## GEUM ENVIRONMENTAL CONSULTING,

On August 4 and 5, 2008, we conducted a site visit of Grave Creek project Phases 1 and 2. The purpose of this site visit was to finalize quantities and locations for riparian revegetation treatments included in *Grave Creek Riparian Revegetation and Monitoring Plan (2008)* and currently contracted for implementation under Task Order #0804. To evaluate current site conditions (and to record any changes since December, 2007), we collected monitoring data at sites evaluated in December 2007, coordinated with John Muhlfeld in the field to quantify necessary structure repairs, bioengineering locations, and associated materials and labor needs..

The purpose of this letter is to provide you with an updated treatment list, treatment quantities and treatment locations proposed to be implemented under Task Order #0804.

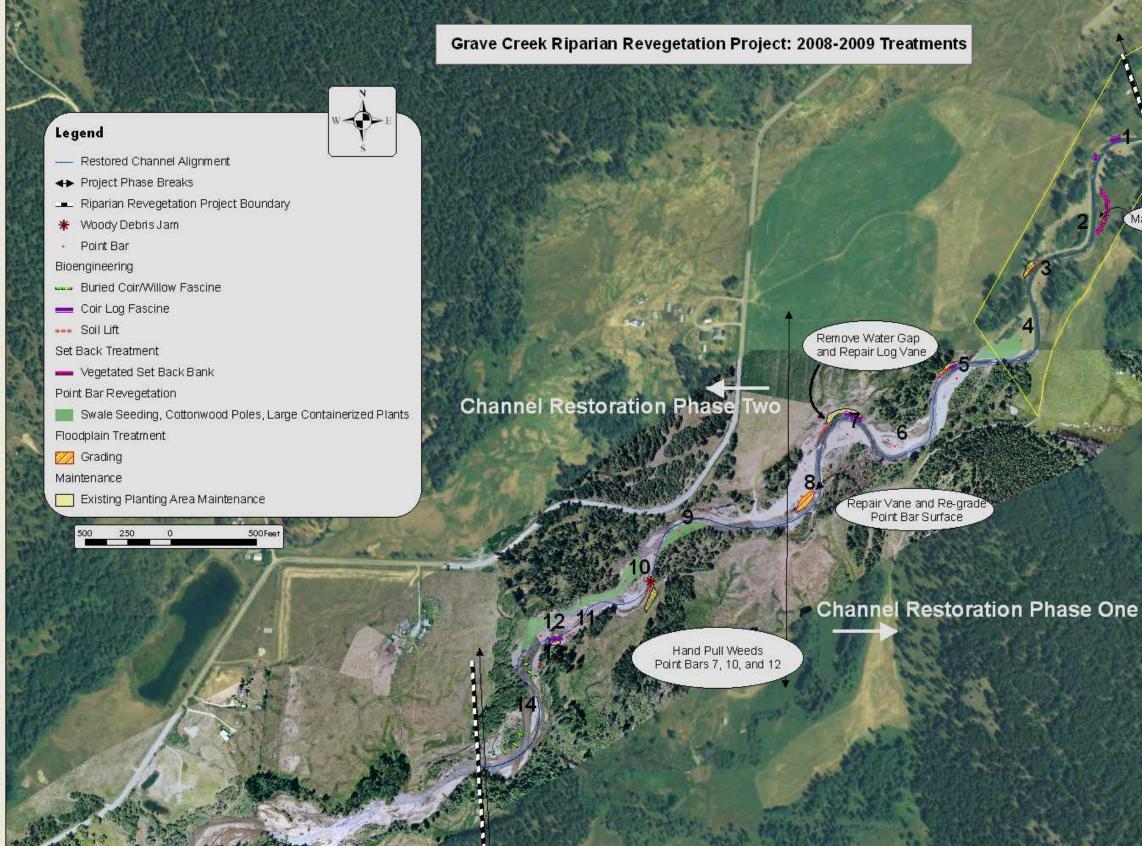
The treatments remain relatively unchanged, but the quantities and locations were adjusted to some extent. Changes are described below, and quantified in the attached table. The original treatment quantities are also included for comparison. The primary adjustments to the proposed treatments in the revegetation plan include:

• Construction of approximately 6,000 feet of 8-strand electric slant fence to reduce whitetail deer impacts to newly establishing woody vegetation. This fencing includes the Demonstration Phase and approximately half of Phase 1. The location of the fencing was determined based on numerous

- Reduction of floodplain grading area treatments (*Floodplain Treatment from the 2008 Plan*). During our site visit we observed cottonwood recruitment on a number of floodplain surfaces. Floodplain grading will require access to these areas by heavy equipment and excavation of portions of these areas. As originally proposed, this treatment would have resulted in disturbance to a number of these surfaces and we felt that giving the naturally recruited vegetation a chance to establish on its own was more important.

- Need for repairs to a second log vane structure.
- Adjustment of bioengineering structure lengths and locations. During our August field visit, we finalized these locations and lengths on the ground, and refined the techniques for each location.

- Elimination of the one proposed riparian planting area based on the amount of natural regeneration that occurred this year on that surface and the fact that the site will now be located within fenced area.

- Extension of the *Vegetated Set Back Bank* treatment. Based on further observations of this site, we decided this treatment would be beneficial to the long-term stability of this reach of Grave Creek. During our site visit, we selected appropriate tie-in points, which resulted in a slightly longer trench than originally proposed.

Included is a map showing the revised locations of treatments based on the site visit, a table listing the proposed quantity of each treatment and a table listing the quantity of each treatment that was used to develop the cost estimate and
